ROCKY FLATS SITE REGULATORY CONTACT RECORD

Purpose: Soil Disturbance Review Plan - Roads upgrade project involving reconfiguration of a sharp curve west of Functional Channel 1

Rocky Flats Legacy Management Agreement (RFLMA) Soil Disturbance Review Plan

Proposed Project: Roads upgrade project involving reconfiguration of a sharp curve west of Functional Channel 1

Figure 1. Project Location and Extent of Excavation

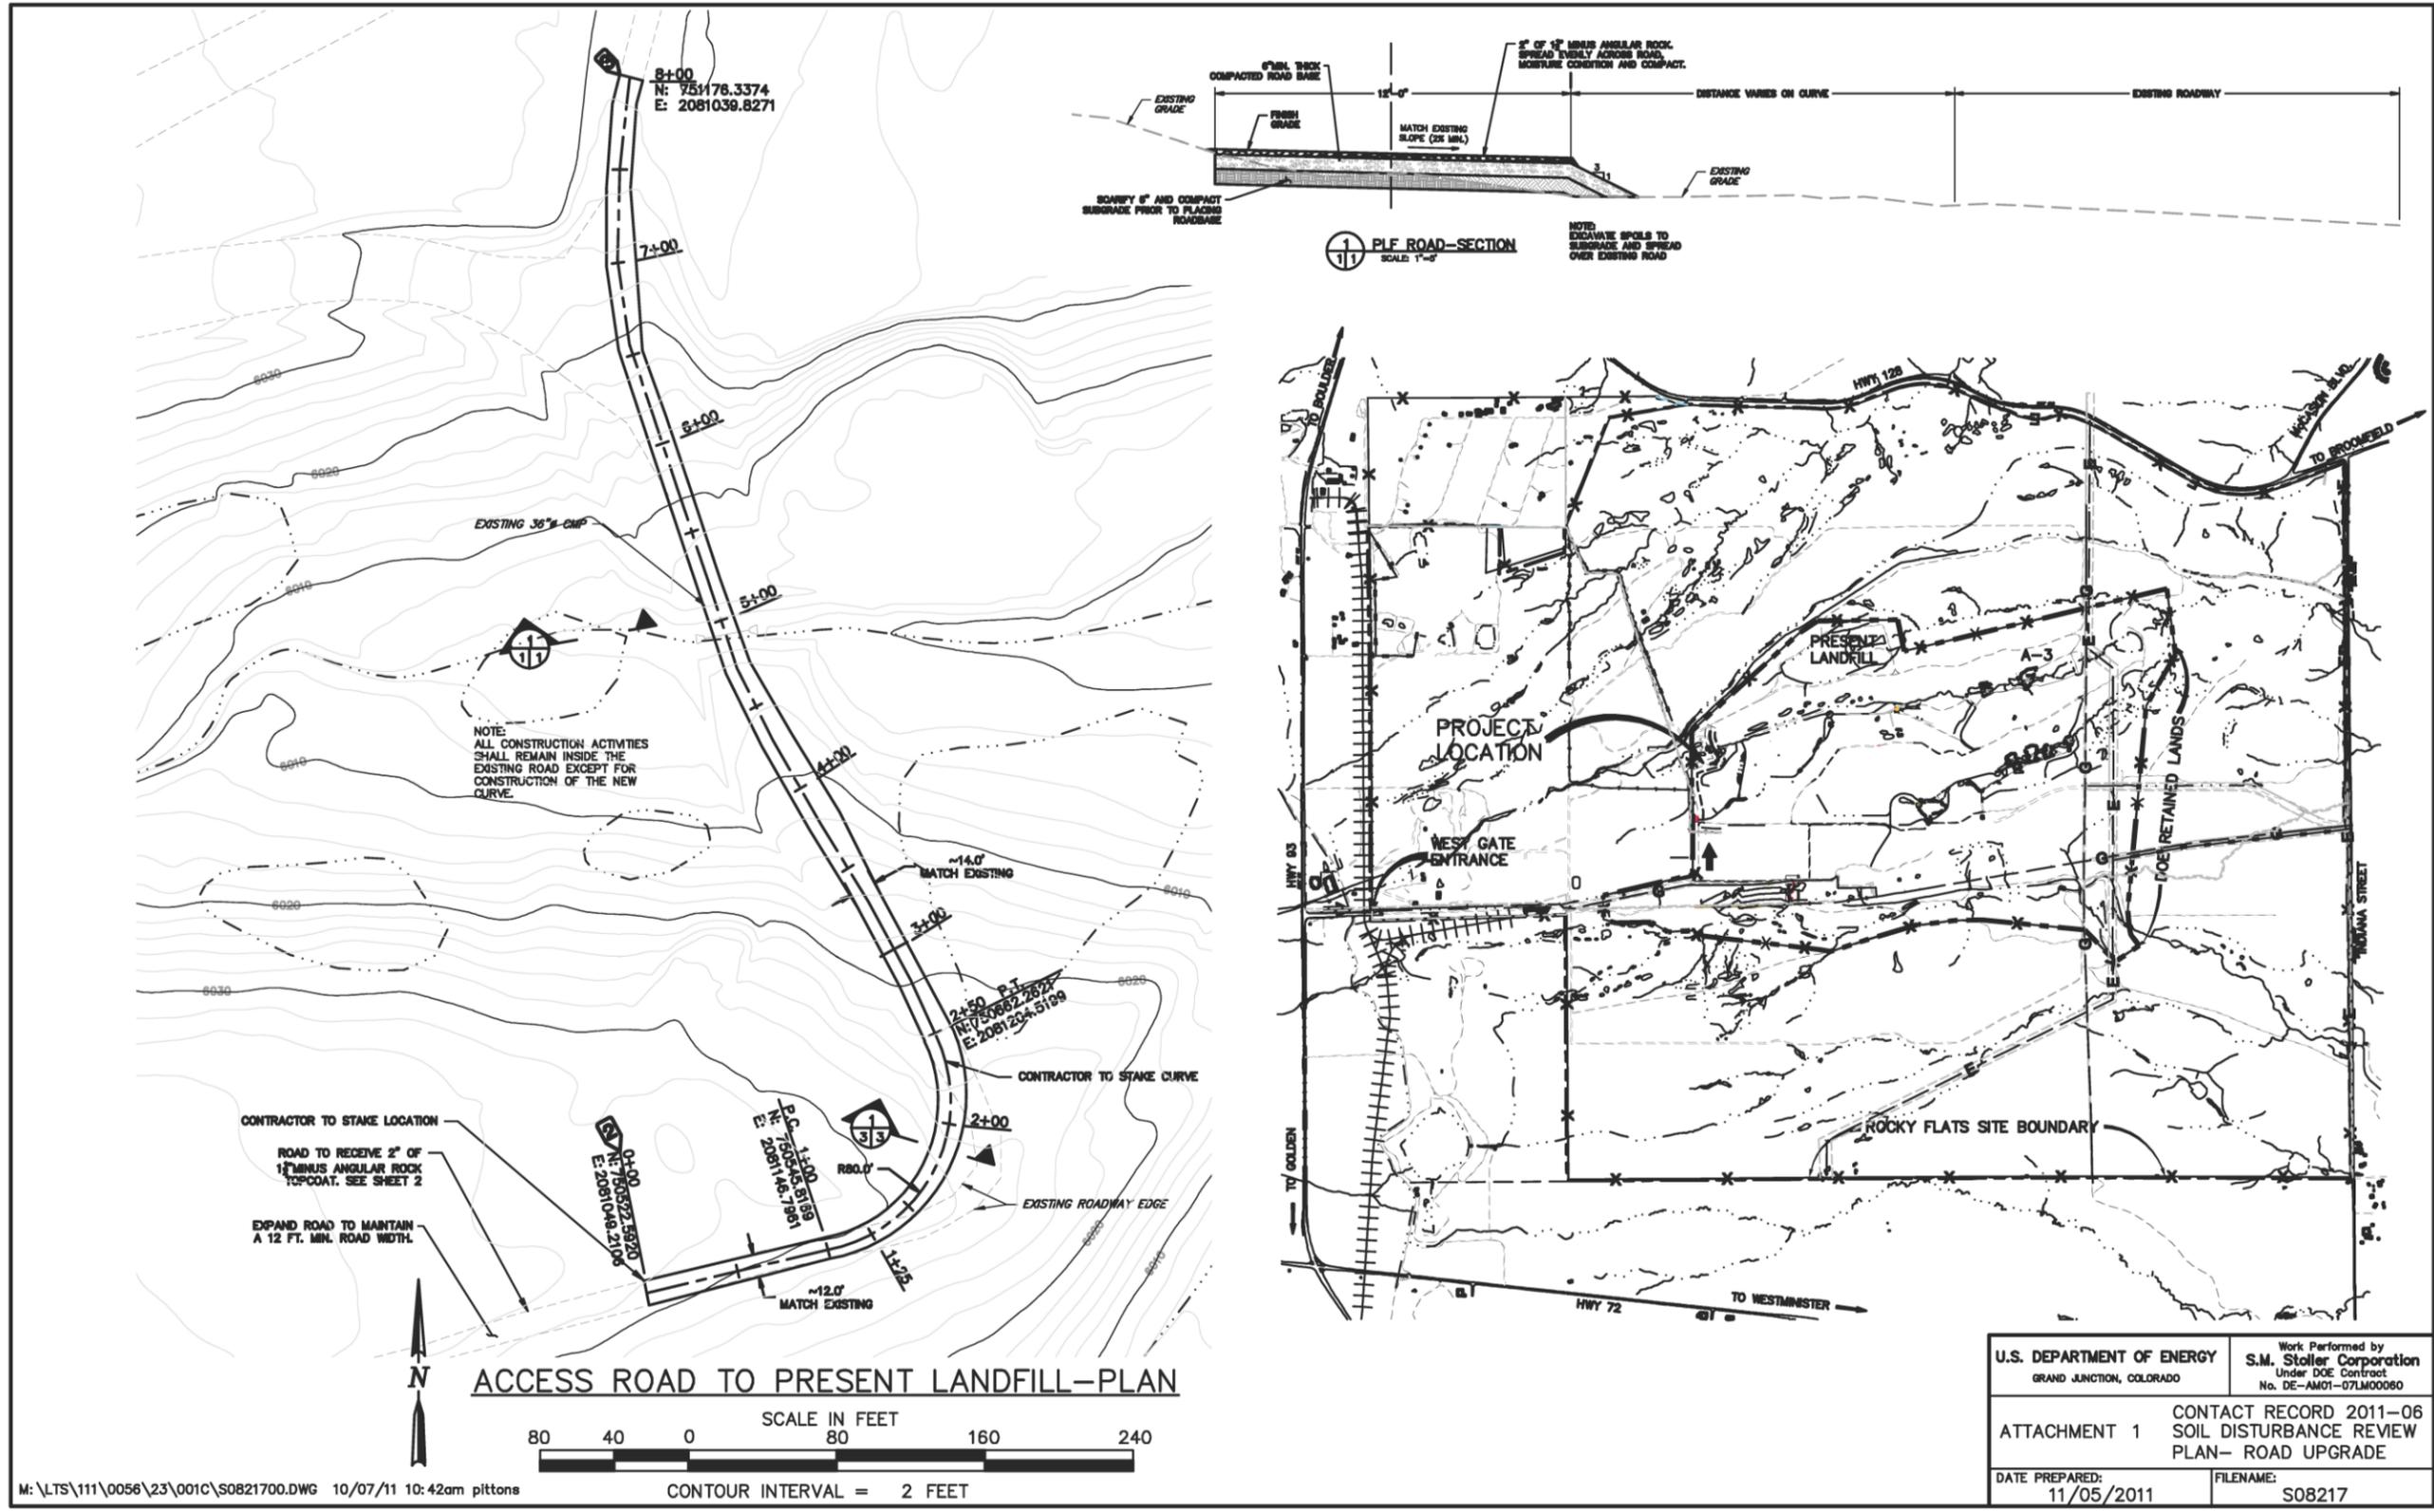
The purpose of the project is to maintain and improve the section of gravel road shown in Figure 1. The improvement regrades the area and takes out a sharp curve that is on the edge of a sloping embankment to result in wider radius curve that is farther away from the sloping embankment. The planned location, lateral and vertical extent, and grade upon completion of the work are shown in Figure 1. The excavation for regrading this portion of the road will be approximately 6 feet deep at the deepest portion.

This characterization information is sufficient for DOE to implement appropriate worker health and safety controls for the soil disturbance. Disturbed soils will be regraded in the work area as shown in Figure 1.

Resolution: Carl Spreng, CDPHE, approved the soil disturbance and excavation work described in the Soil Disturbance Review Plan.
